From: Ian Sutherland <isutherland@accenv.com>
Sent: Tuesday, November 29, 2016 12:57 PM
To: Jurek, Anne, Env. Health
Cc: amunoz@midpen-housing.org; aujimori@midpen-housing.org
Subject: Re: ACEH Correspondence RO3179
Attachments: Figure 2 - Historic Soil Boring Locations (Closeup of Former Gasoline Service Station)_1625 Chestnut Steet_Livermore.pdf; TABLE 3 (REV 11.29.16) - Soil Analytical Results Summary (TPH, VOCs & OCPs).xls.pdf; TABLE 4 (11.29.16) - Soil Analytical Results Summary (PAHs & Metals).xls.pdf

Hope you had a nice Thanksgiving. I just have a couple questions regarding the draft work plan for 1625 Chestnut Street. The October 24, 2016 ACEH letter requesting a draft work plan notes that samples collected from 0-5 ft bgs were not analyzed for naphthalene. Please see the attached Table 4 indicating that URS samples between 0 and 5 ft bgs in the vicinity of the former gas station were analyzed for naphthalene and other PNAs. I additionally attached the updated Table 3, which has been revised to show the correct reporting limits for MBTEX. ACC's opinion is that the 0 to 5 ft bgs range in the vicinity of the former gasoline service station has been sufficiently characterized

FIGURE 2

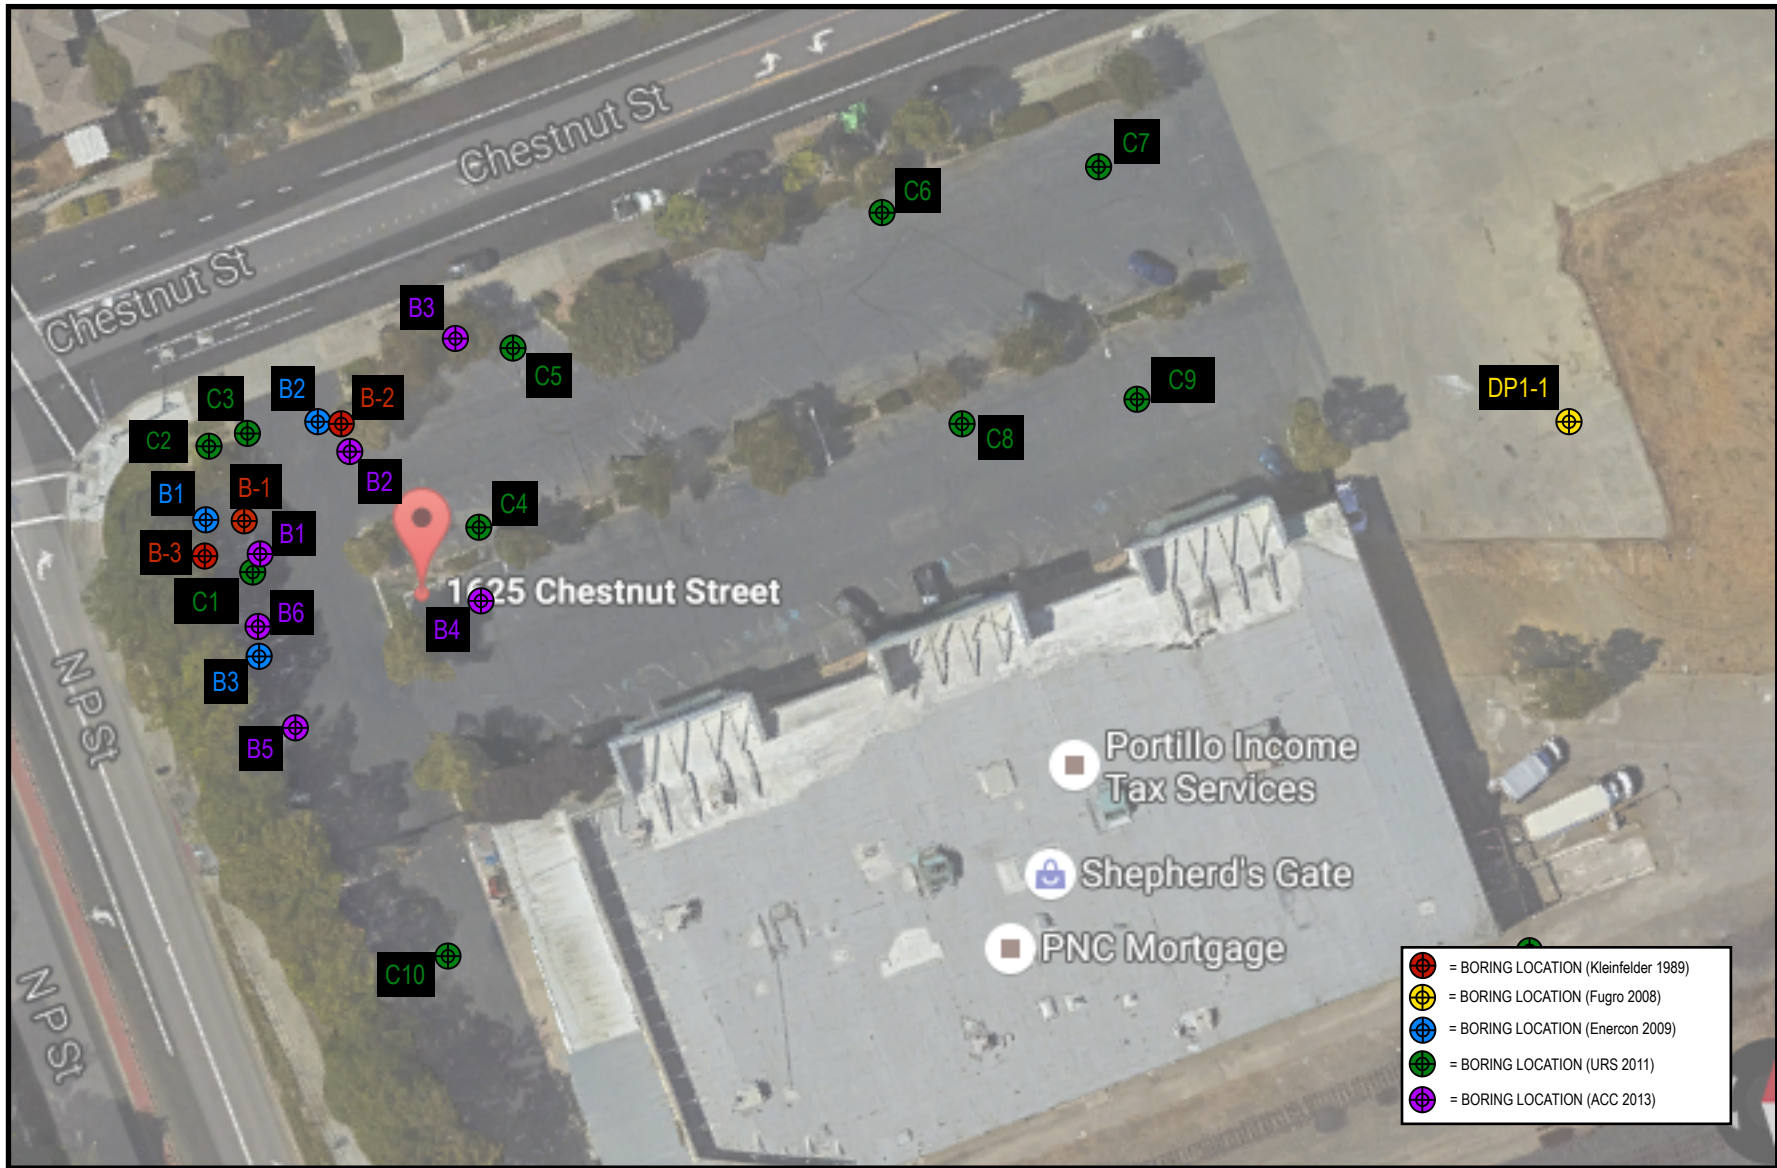
ACC agrees that additional sampling from 5 to 10 ft bgs at the location of the former gasoline service station is warranted. In an effort to minimize analytical costs, would it be acceptable to analyze all TPH samples (including other areas of the Site) without silica gel cleanup and half of those with silica gel cleanup (or vice versa)?
